Wisconsin Department of Transportation

Proposal #08: 2250-16-70, WISC 2018 176
Washington Ave, V Mount Pleasant
IH 94 to CTH H
STH 20
Racine County

This is Addendum No. 01, which provides for the following:

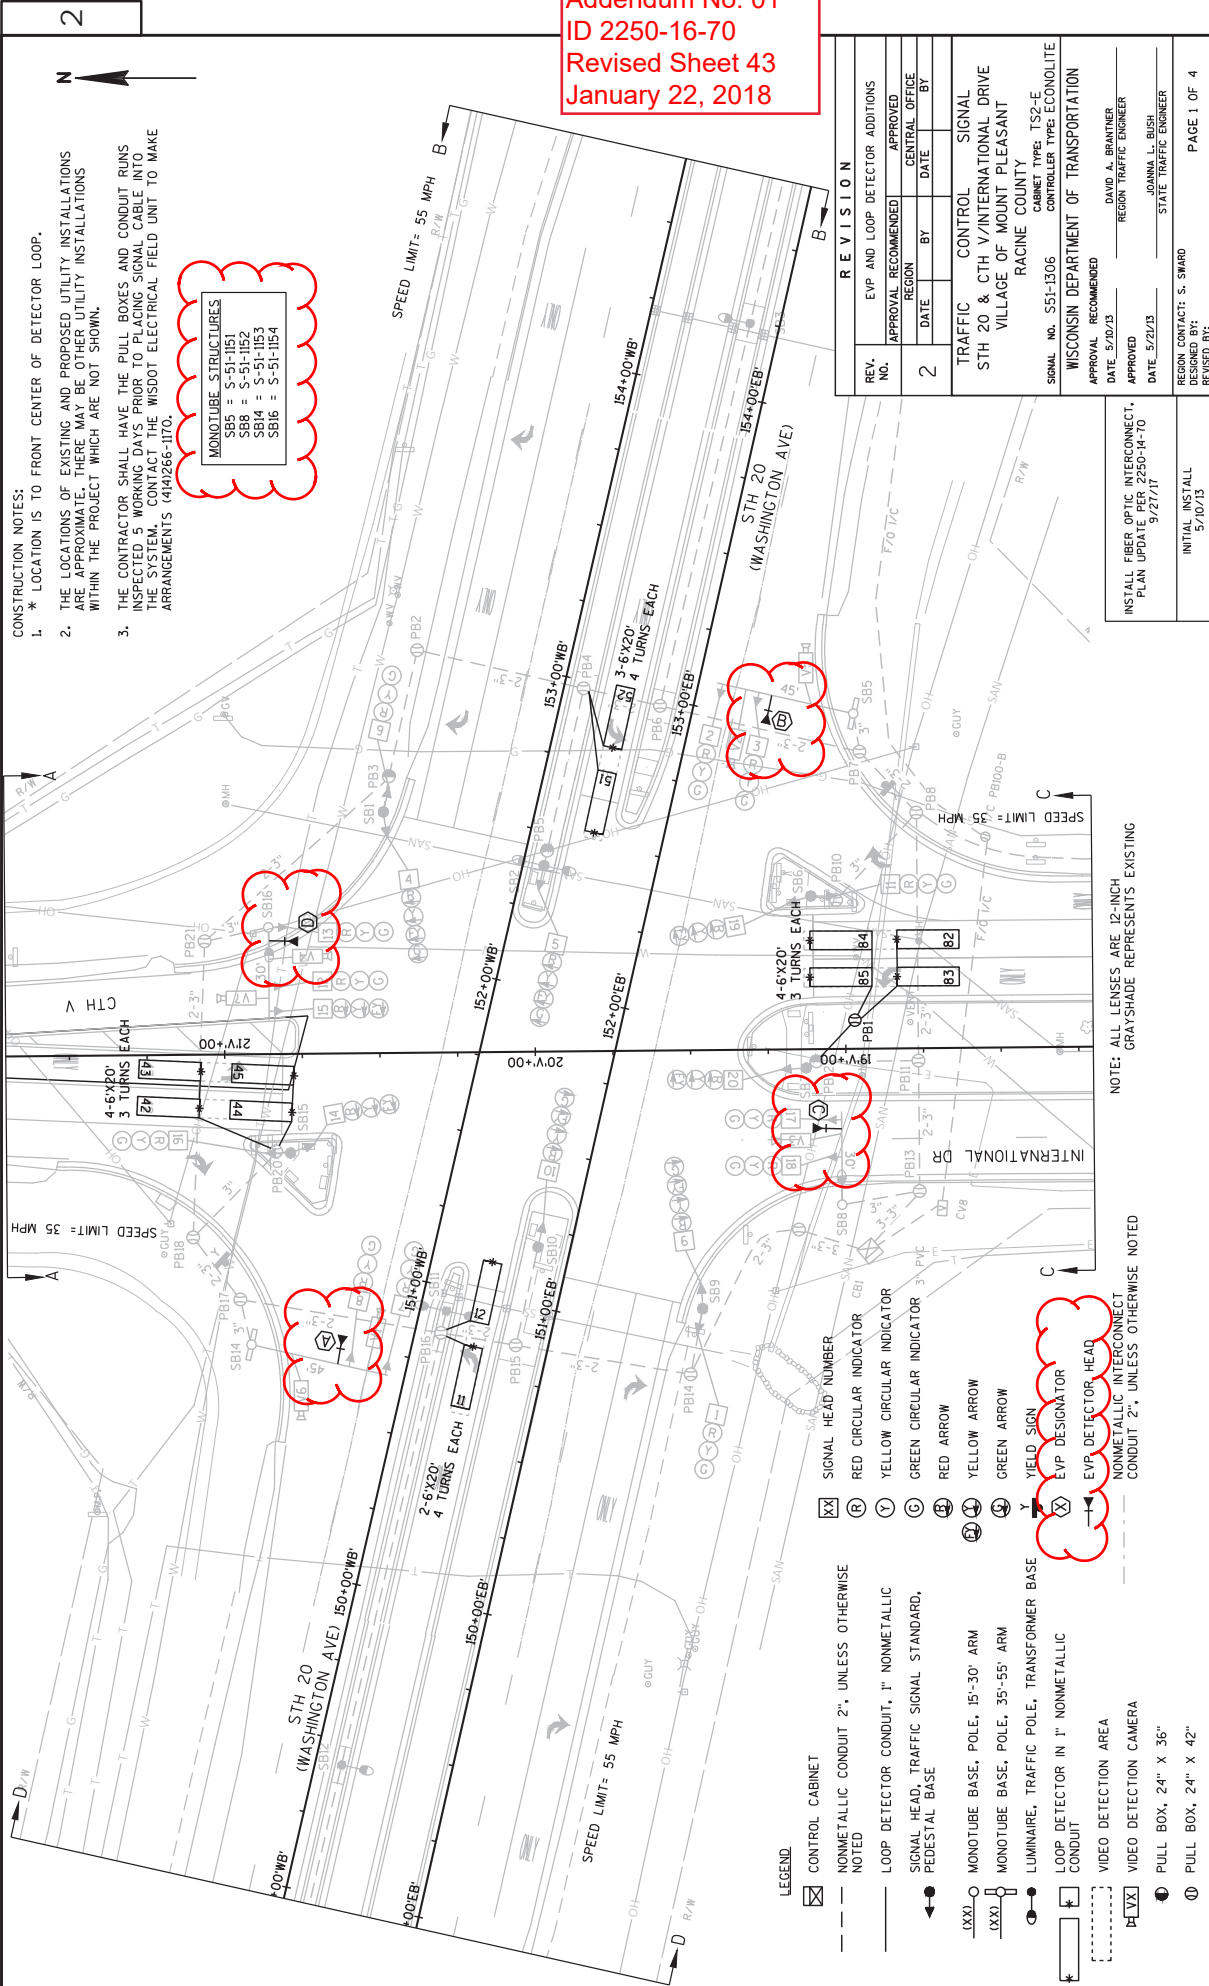
Revised Plan Sheets	
Plan Sheet	Plan Sheet Title (brief description of changes to sheet)
43	Removed the EVP Confirmation Lights from the CTH V intersection plans
49	Rotated the monotube base/wings at SB 14 90 degrees to avoid a potential utility conflict
90	Modified miscellaneous quantities table to account for revised EVP detection design
